CLIENT		
ABIB (OAMARU) LTD		
PROJECT		
GOODLAND COASTAL FARM		
TITLE		
EROSION & SEDIMENT CONTROL ADJACENT TO WETLAND		
DRAWN	TG	SCALE A1 1:25
DESIGNED	TG	A3 1:50
PROJECT No 1366	DRAWING No C227	REVISION A

To: Zoe Avery - The Urbanist
From: Zibo Yang - Crang Consulting
cc: Hari Hari - Goodland
Date: January 31, 2024
Re: 2127 Kaipara Coast Highway – Formal S92 Response – Rev 1

The following responses address items relevant to civil engineering within the Section 92 request letters. The queries responded to herein are cited in italics for ease of reference, with the corresponding response below. Each question retains the same number and wording as in the letter for ease of reference.

CLIENT	ABIB (OAMARU) LTD		
PROJECT	GOODLAND COASTAL FARM		
TITLE	CULVERT OVERALL PLAN		
DRAWN	MA	SCALE A1 1:2000	
DESIGNED	MA	A3 1:4000	
PROJECT No	1366	DRAWING No	C470
		REVISION	A

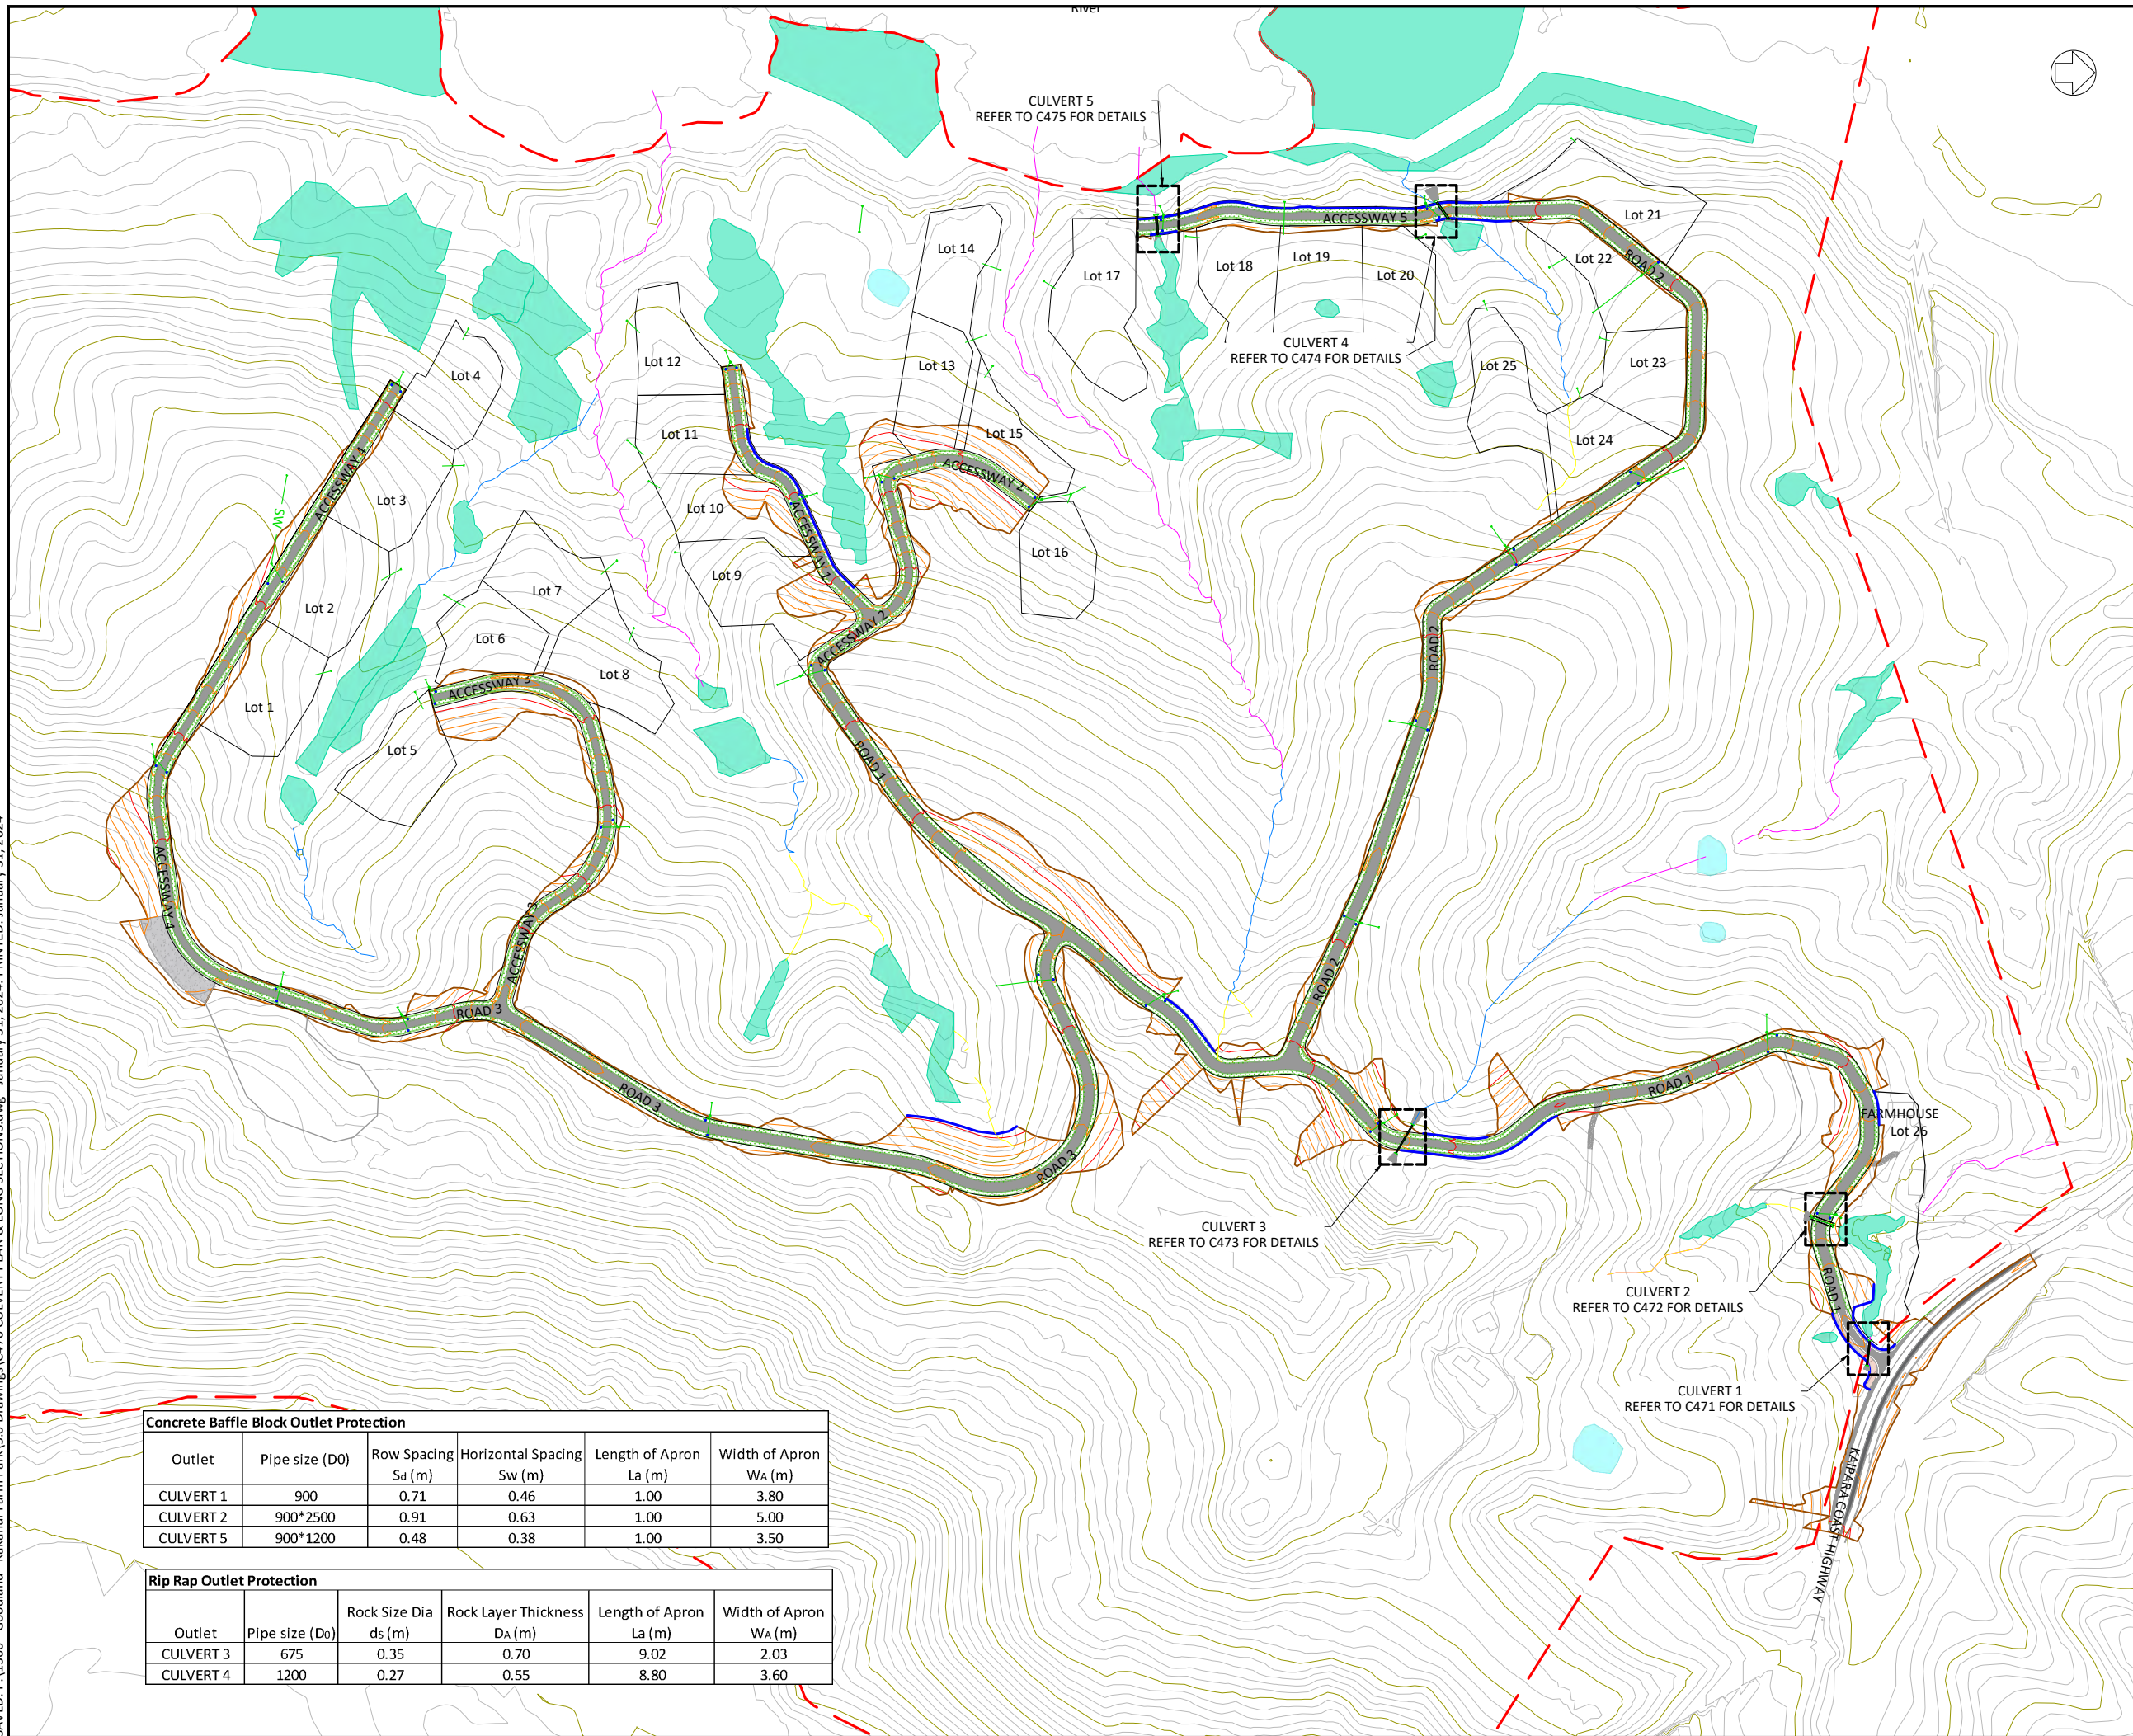
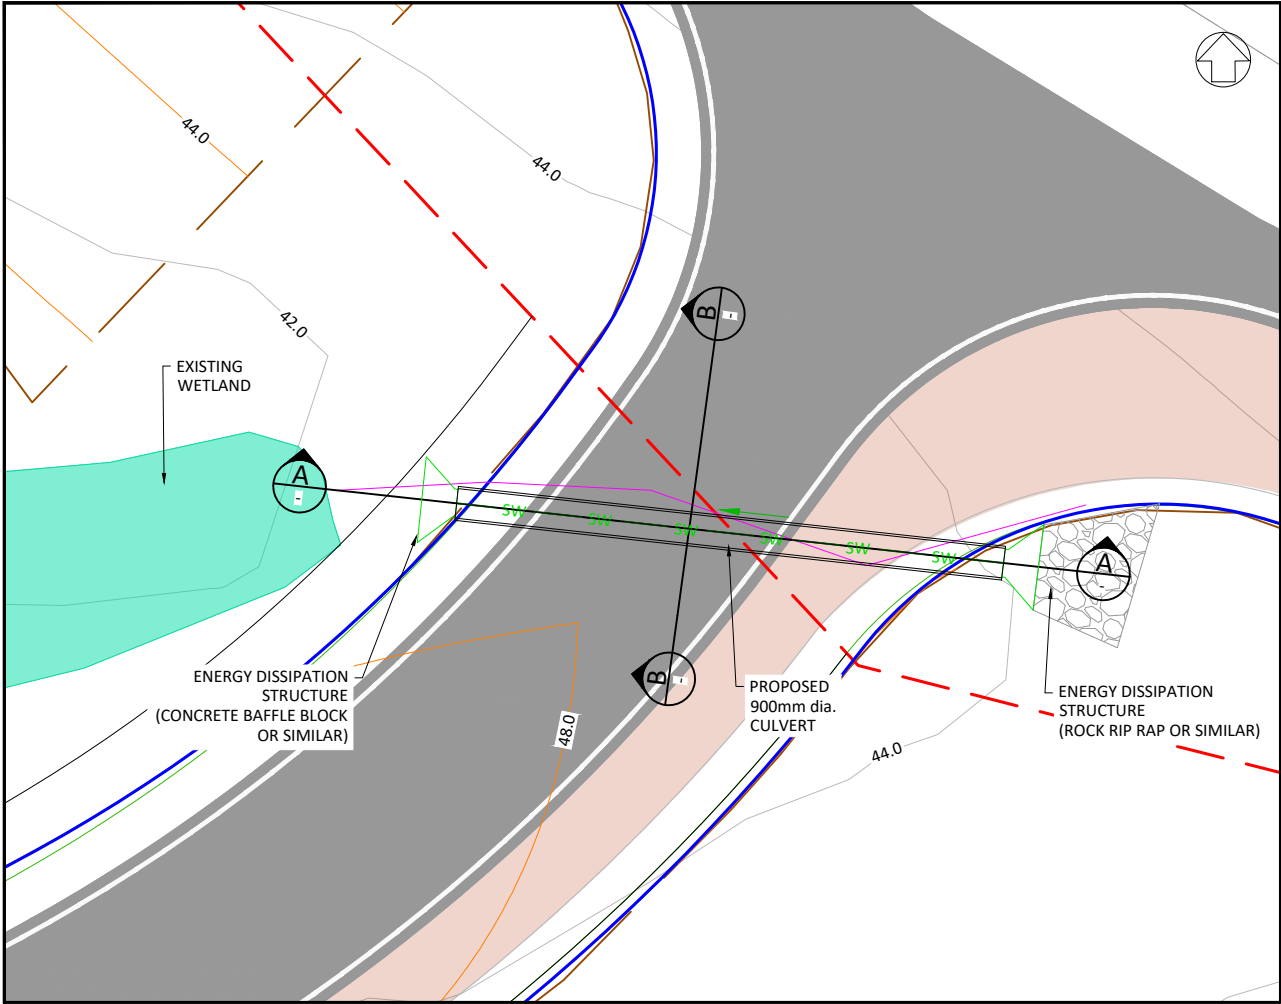
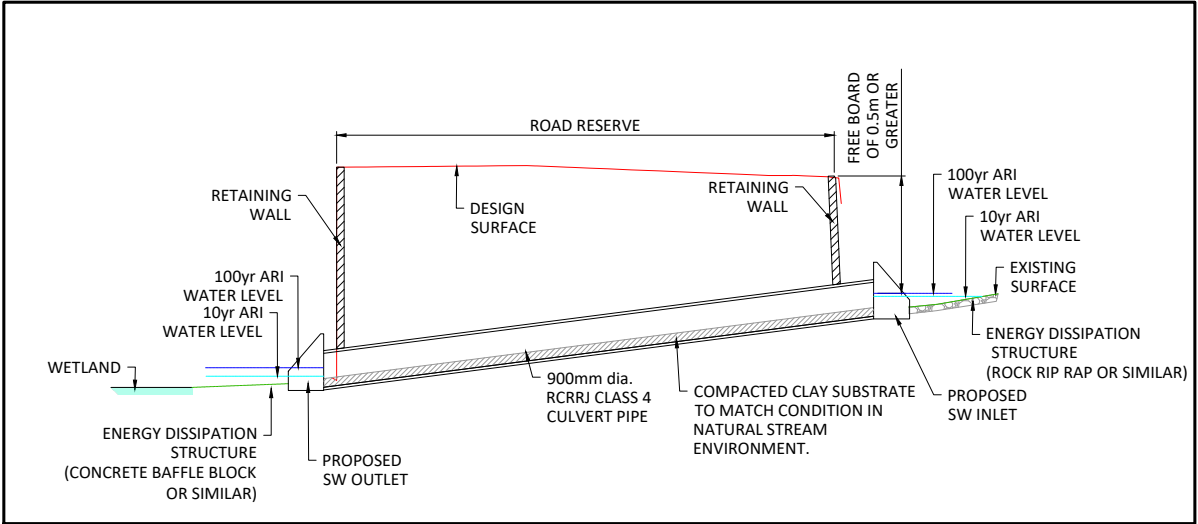
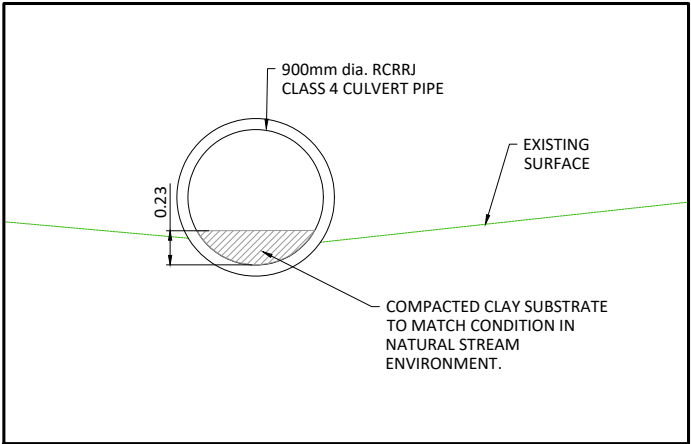
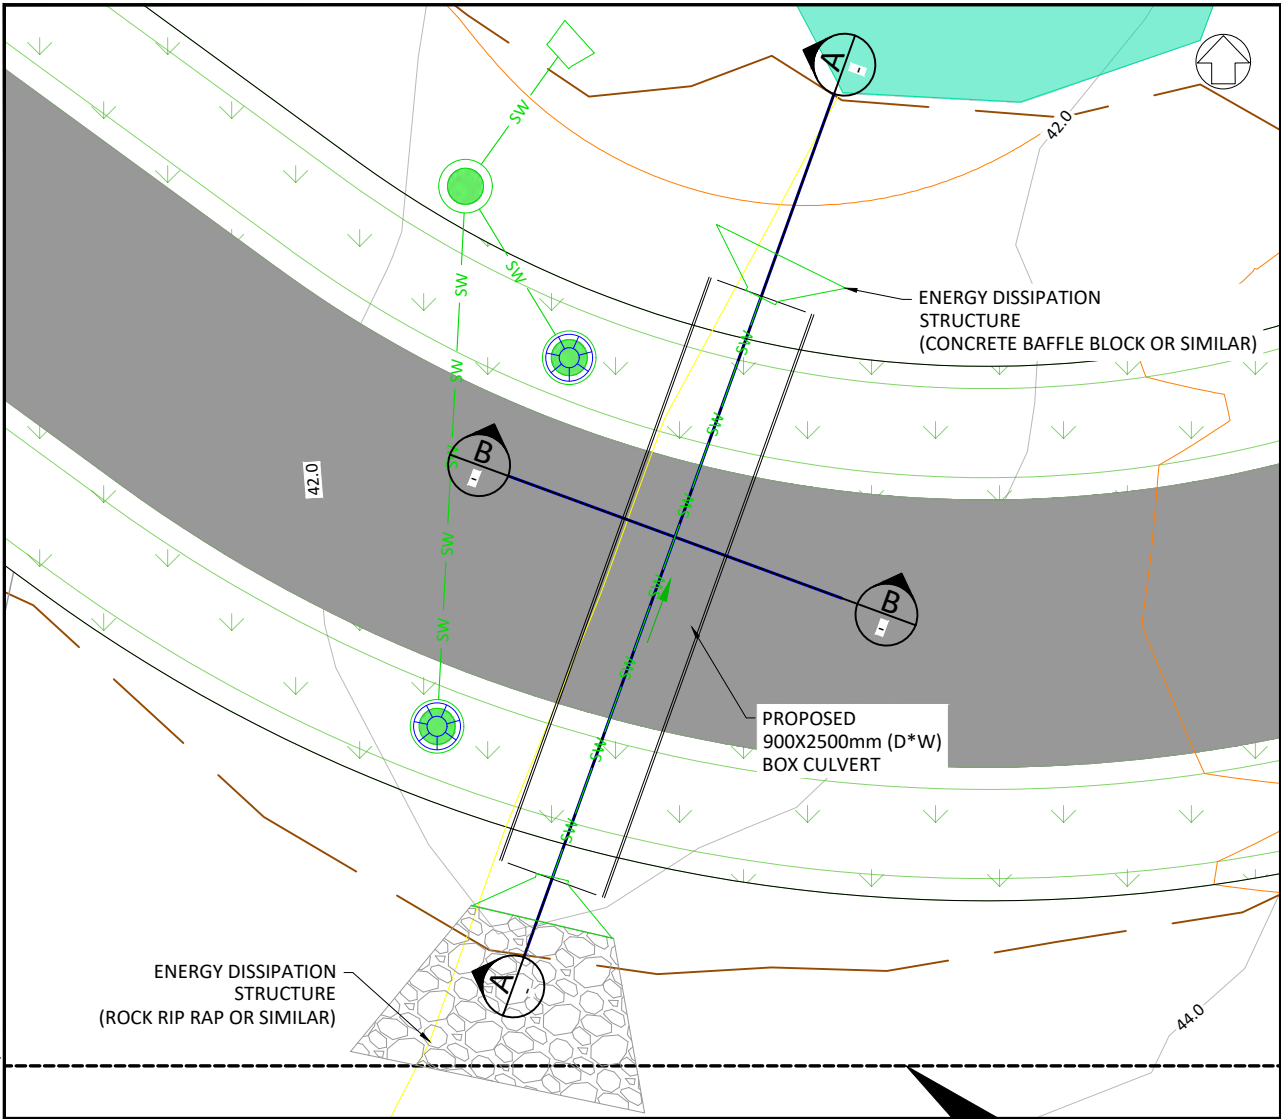
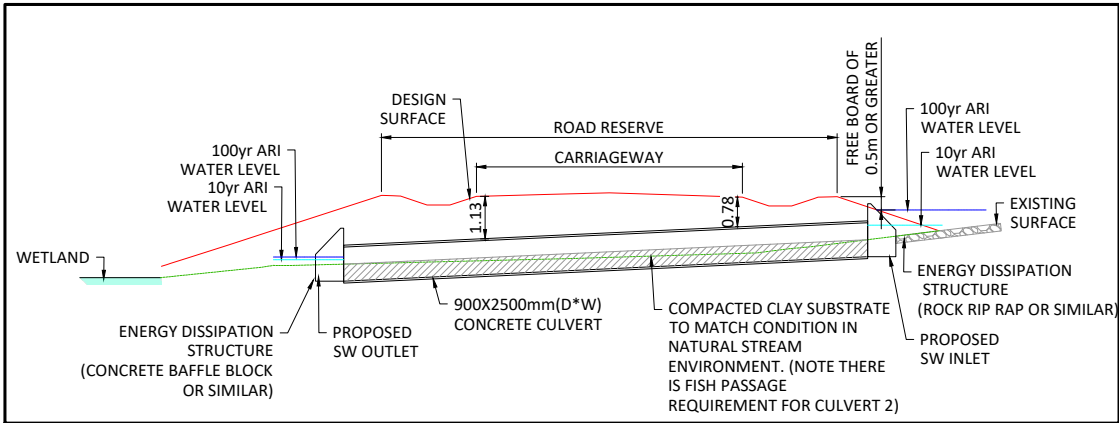
Query No. 62: *The application reports that the culverts are a permitted activity. However insufficient information has been provided with the application to confirm this assessment. Please provide:*

- *Culvert designs in plan form*
- *Culvert design calculations*
- *Stream information (for assessment against Regulation 70(2) of the NES:FW)*
- *The location of all culverts*
- *An assessment of each culvert against the permitted activity condition of Regulation 70(2) of the NES:FW.*
- *An assessment of each culvert against the permitted activity standards associated with rule E3.4.1(A32).*

Please provide the necessary design calculations to confirm the outfalls are a permitted activity; and a plan that shows the outfalls relative to the wetlands

November 2023 comments: A location plan has been provided; however the length of the erosion protection at the outfall has not. Specific design information is required to support the response that has been provided by the applicant's engineers. As this relates to a reason for consent under the AUP:OP it is not considered appropriate to defer this detail to building consent stage.

- a) Culvert designs in plan form and location of all culverts– plans C470 series
- b) Culvert design calculations – Crangcivil's engineering report Appendix C
- c) Stream information (for assessment against Regulation 70(2) of the NES:FW – see summary table below

Please refer to the revised drawings 470 series as well as the culvert calculations in Appendix C of the engineering report for the proposed erosion & sediment measures at the culvert outlets. An assessment of each culvert against the permitted activity standards associated with rule E3.4.1(A32) based on the revised engineering design, see the summary tables provided in query 62.
